TO: Mercedes-Benz Dealer Principals, General Managers, Sales Managers, Service Managers, Parts Managers	FROM: Gregory Gunther, Department Manager, Vehicle Compliance and Analysis, Engineering Services
RE: Recall Campaign Phase 4 Launch Notification 2018030002 (Manual Steering Column) SCM Ground MY14-16 CLA-Class, GLA-Class, B-Class Electric (117, 156, 242)	DATE: March 9, 2018

RECALL CAMPAIGN PHASE 4 LAUNCH NOTIFICATION WITH **RETAIL HOLD**

Campaign No. :	Campaign Desc. :	Steering Control Module Ground (Manual Column Adjustment)
2018030002 (Manual)	1709P46C61 (Manual)	
This is to notify you of a Recall Campaign update for certain Model Year 2014–2016, Model 117, 156, 242ed platform vehicles (CLA-Class, GLA-Class, B-Class electric). Please review the recall information below. The Recall Campaign is visible on the www.safercar.gov website and may generate questions from the media or customers. Please note that this update only accounts for a subset of a larger recall population initially identified in a prior NCU distributed on October 16, 2017. These vehicles will be flagged in VMI as “OPEN” on March 9, 2018. All other vehicles affected by the recall will continue to remain flagged

Figure 6

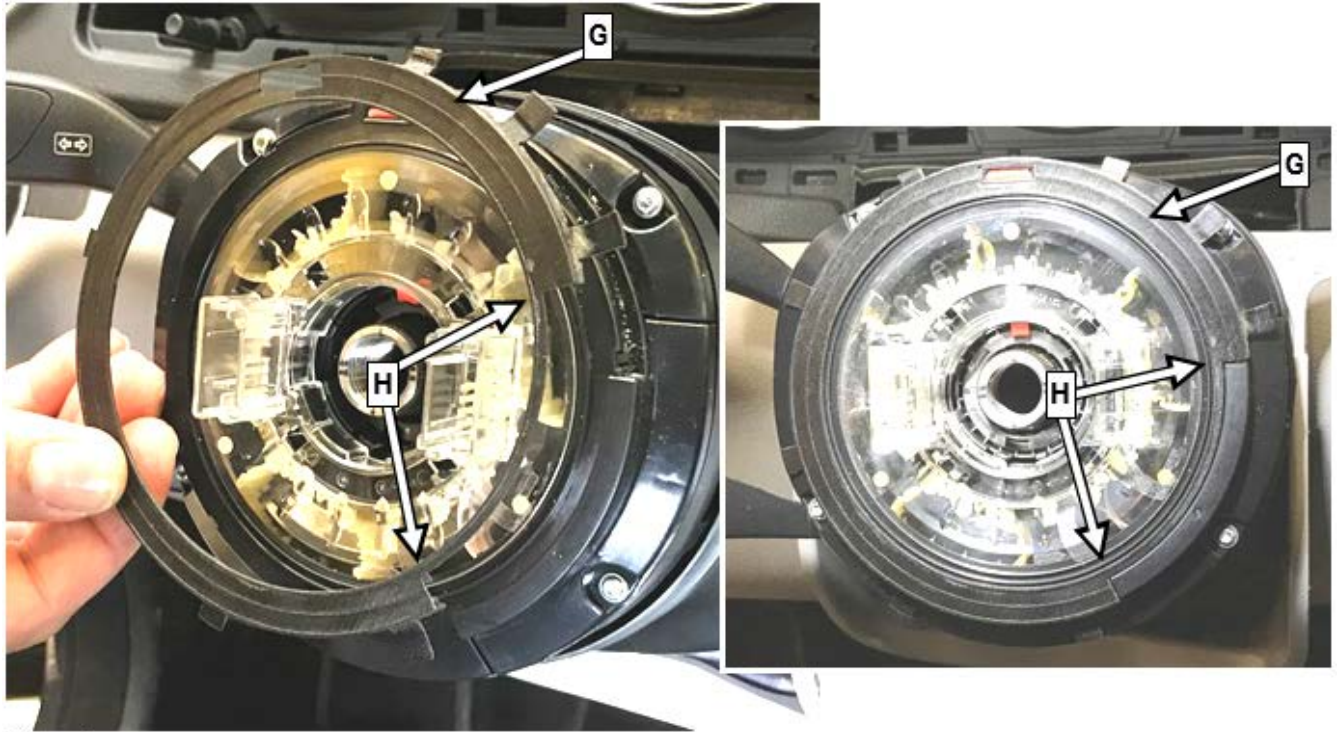
2. Subsequently position protective ring (**G, Figure 6**) on the installed Valeo steering column switch module.
 - i** Protective ring is placed on loosely and then held in place when the cover (**E, Figure 5**) is mounted.
 - i** Observe reference edges (**H, Figure 6**) of steering column switch module in relation to protective ring during assembly.
 - i** Important! It is not possible to retrofit a protective ring for steering column switch modules

Figure 10

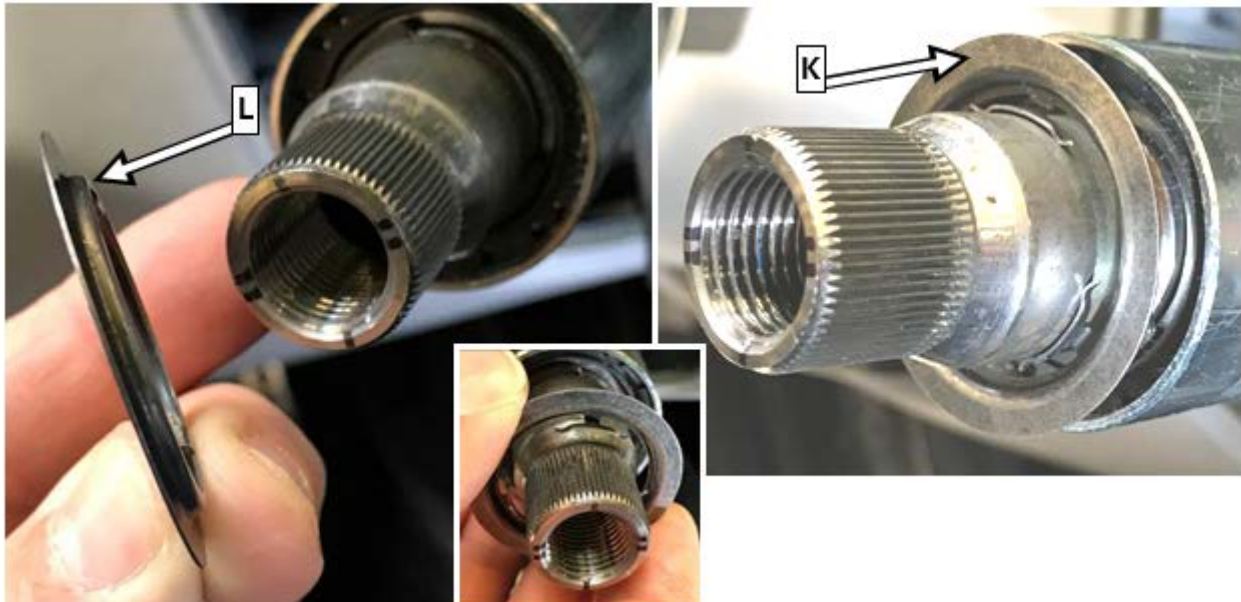
7. Slide Contact Bridge (**K**, figure 10) onto steering column until the end stop is reached.

i Note direction of installation: Lip (**L**, figure 10) on the contact bridge (**K**, figure 10) must face toward the direction of travel.

Figure 11

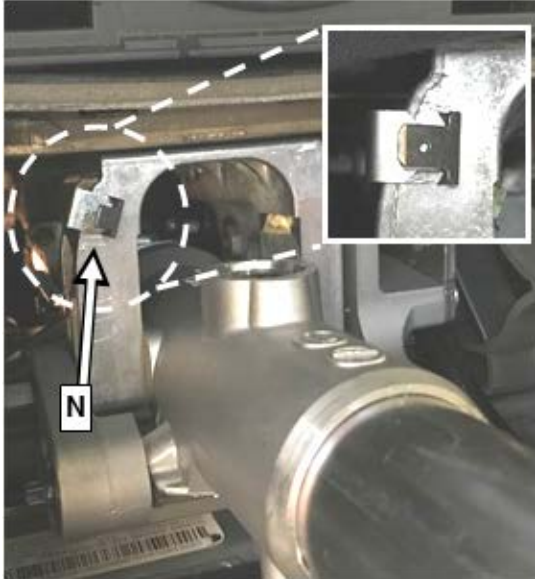
i Slide the contact clip (**N**, figure 11) above the left horizontal crossbar (**O**, figure 12) onto the true vertical rib of the steering column.

figure 12

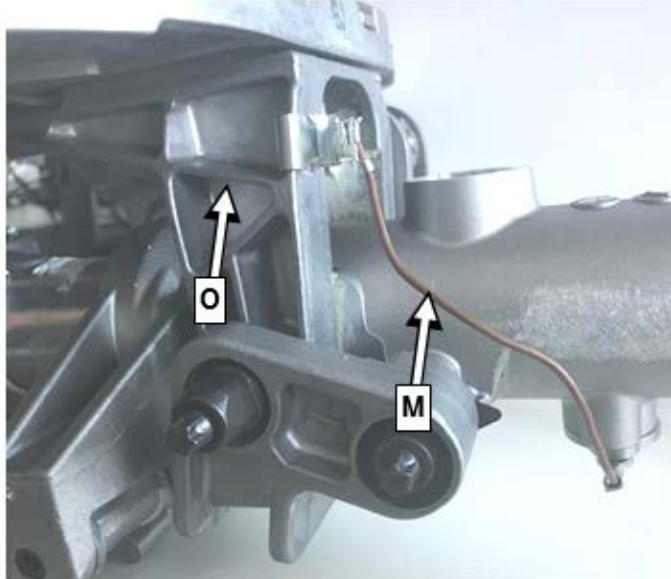
8. Subsequently install ground line (**M**, figure 12) on the electrically adjustable steering column.

- i** Important: No other assembly position is permissible!
- i** Slide the ground line (**M**, **figure 12**) (angled downward) onto the contact clip (**N**, **figure 11**).
- i** Remove the screw (**P**, **figure 13**) and tighten the ground line with the flat side of the eyelet and a new screw onto the steering column.
- i** Before tightening the screw (**P**, **figure 13**), position the ground line's eyelet at a 90° angle to the steering column (**figure 13**).
- Nm** Screw (**P**, **figure 13**) on the steering shaft: **4 Nm**
